STAFF RECOMMENDATION

1903 Beechwood Avenue

August 19, 2020

Application: New Construction—Addition;
District: Belmont-Hillsboro Neighborhood Conservation Zoning Overlay
Council District: 18
Base Zoning: RS7.5
Map and Parcel Number: 10416025300
Applicant: Josh Shambaugh, Nine12 Architects
Project Lead: Melissa Baldock, melissa.baldock@nashville.gov

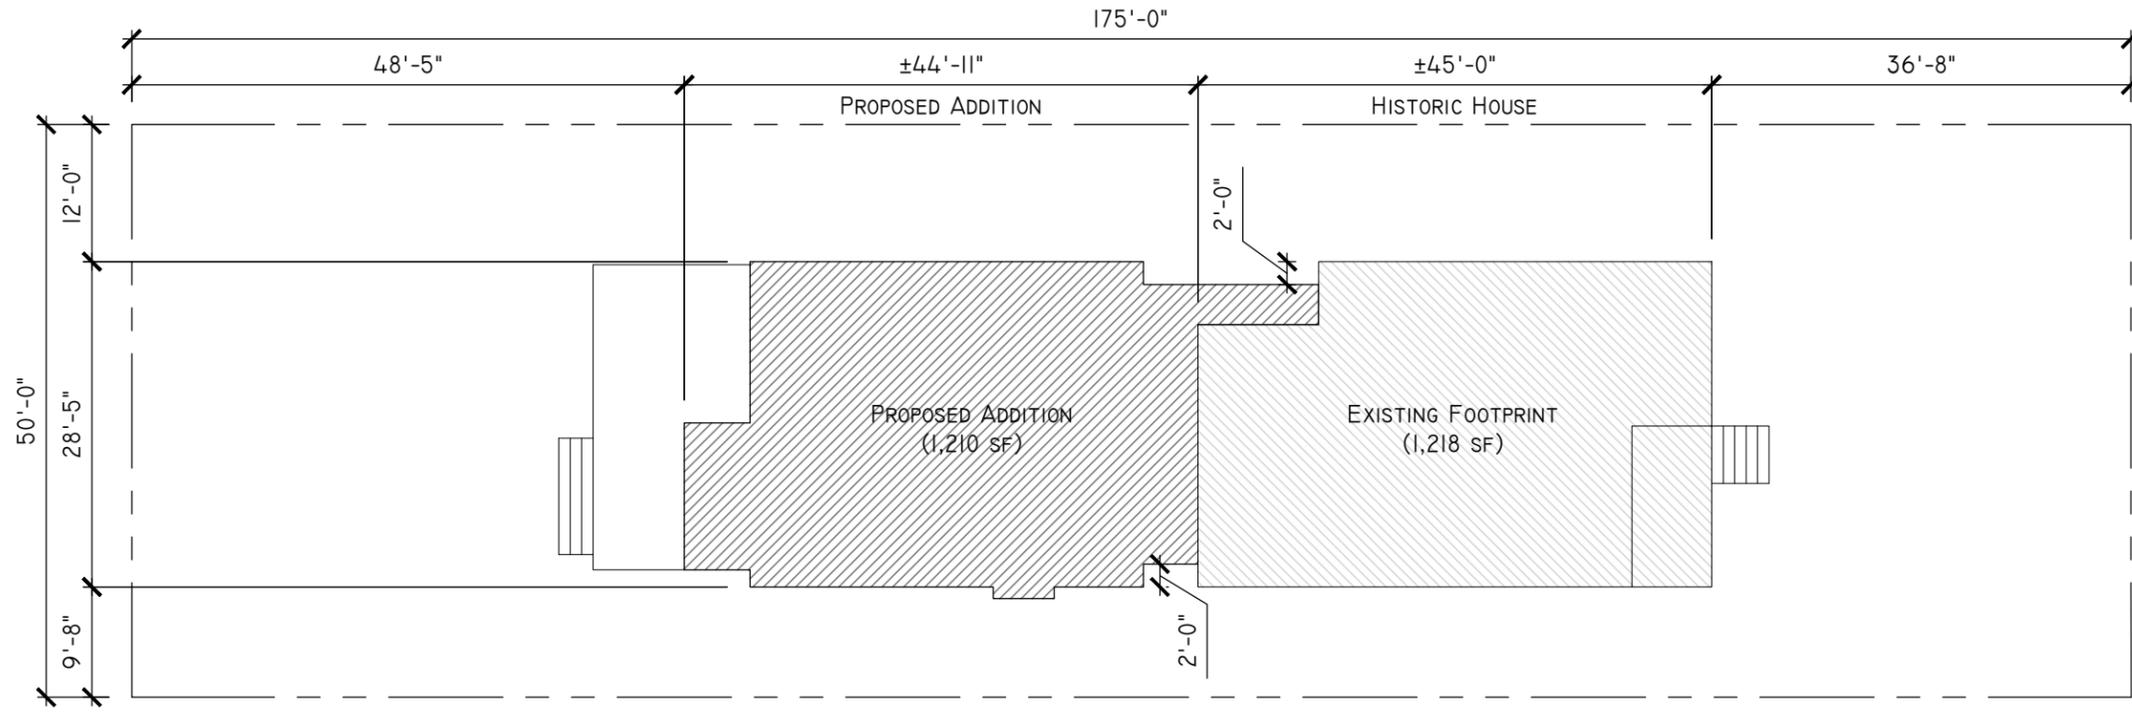
Roof form: The historic house's main roof form is a side gable with an 8/12 slope. The addition connects to the historic house with a gabled connector that has a 4/12 slope. The main form of the addition is a side gable with an 8/12 slope, similar to the historic house's roof form. The rear has a gabled dormer with an 8/12 pitch and a shed bay with a 4/12 pitch.

Staff finds that the proposed roof forms meet Sections II.B.1.e. and II.B.2. of the design guidelines.

SITE PLAN

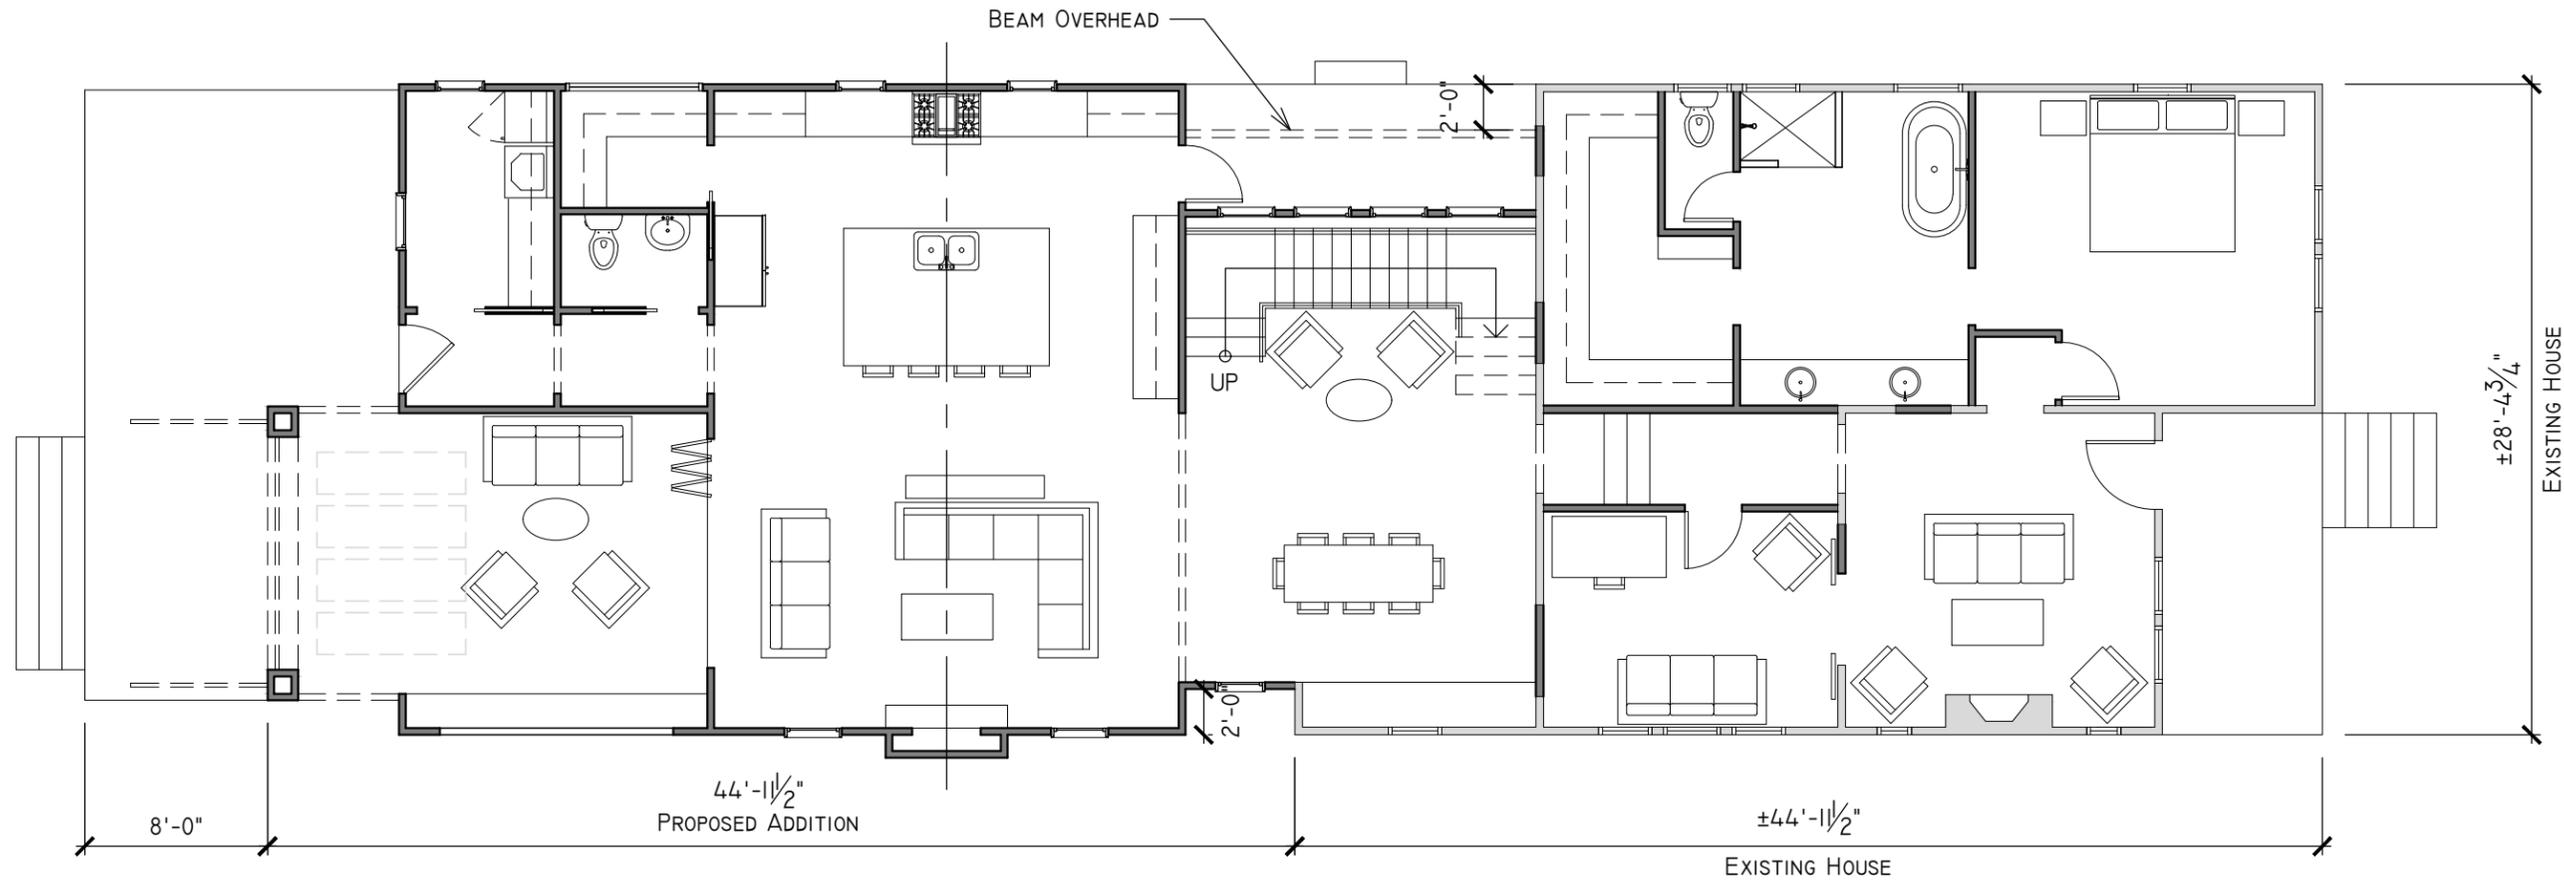
Setback & Rhythm of Spacing: The proposed addition meets all base zoning setbacks. It is twelve feet (12') from the right side property line, nine feet eight inches (9'8") from the left side property line, and forty-eight feet, five inches (48'5") from the rear property line.

Staff finds that the proposed setbacks meet Section II.B.1.c. and II.B.2. of the design guidelines.

BUILDING ELEVATIONS

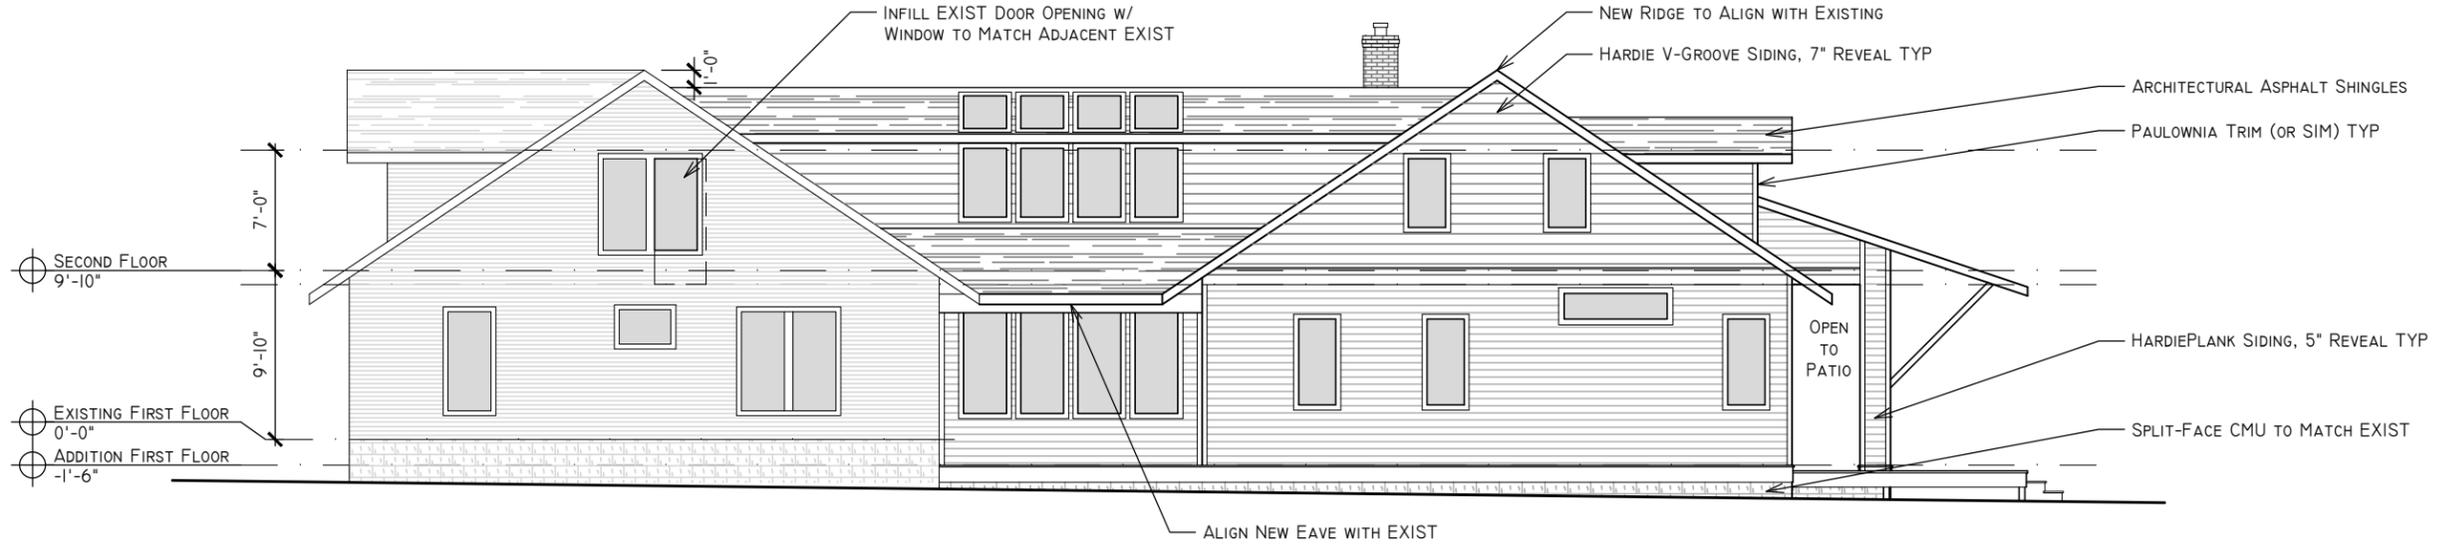
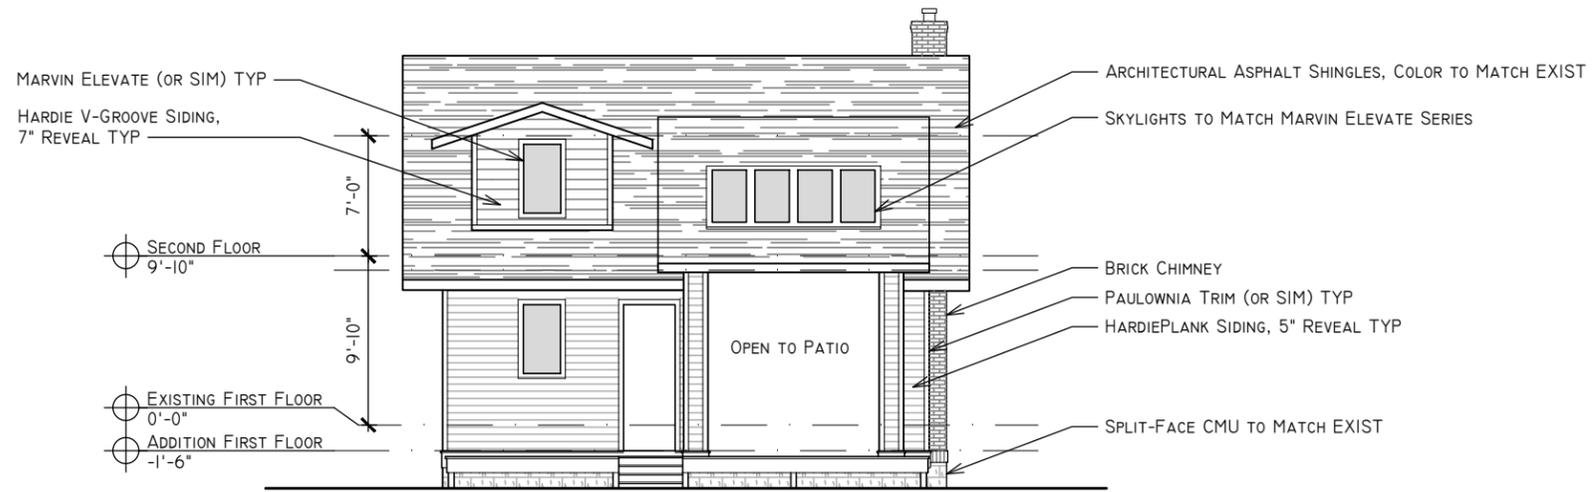
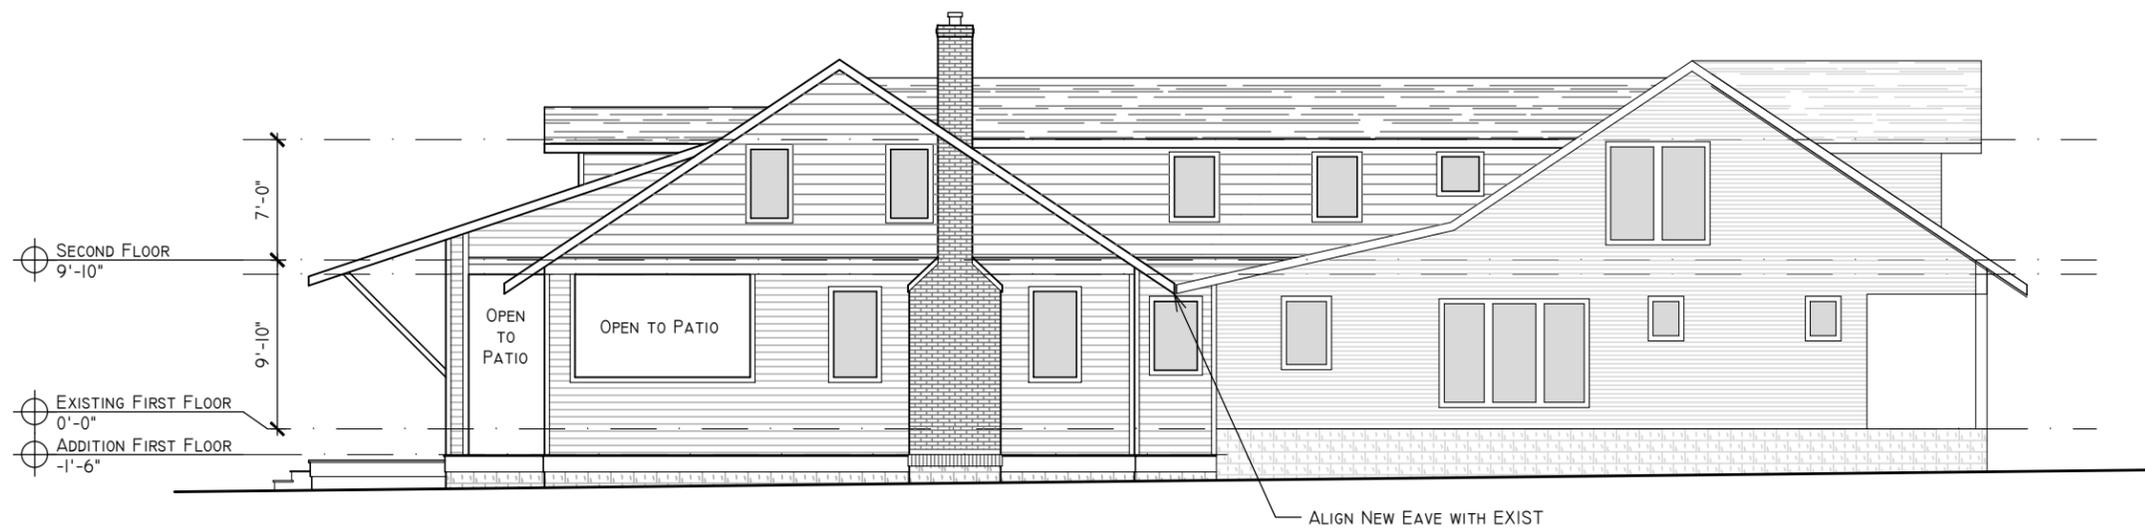
Height & Scale: The proposed addition will be no taller and no wider than the historic house. Its ridge and eave heights will largely match those of the historic house. The foundation will sit lower than the historic house's foundation. The addition is inset two feet (2') from both back corners. On the left side, the addition's inset is four feet (4') deep. On the right side, the addition's inset is over fifteen feet (15') deep. Staff finds that these insets meet the design guidelines. The footprint of the addition will double the footprint of the historic house, which also meets the design guidelines.

Proportion and Rhythm of Openings: The only alteration to the window on the historic house were discussed under "Partial Demolition." The windows on the proposed addition are all generally twice as tall as they are wide, thereby meeting the historic proportions of openings. There is one horizontal window opening on the right façade, more than fifty feet (50') back from the front of the house. Staff finds this to be appropriate because it will not be highly visible from the street. There are no large expanses of wall space without a window or door opening.

Staff finds the addition's proportion and rhythm of openings to meet Sections II.B.1.g. and II.B.2. of the design guidelines.
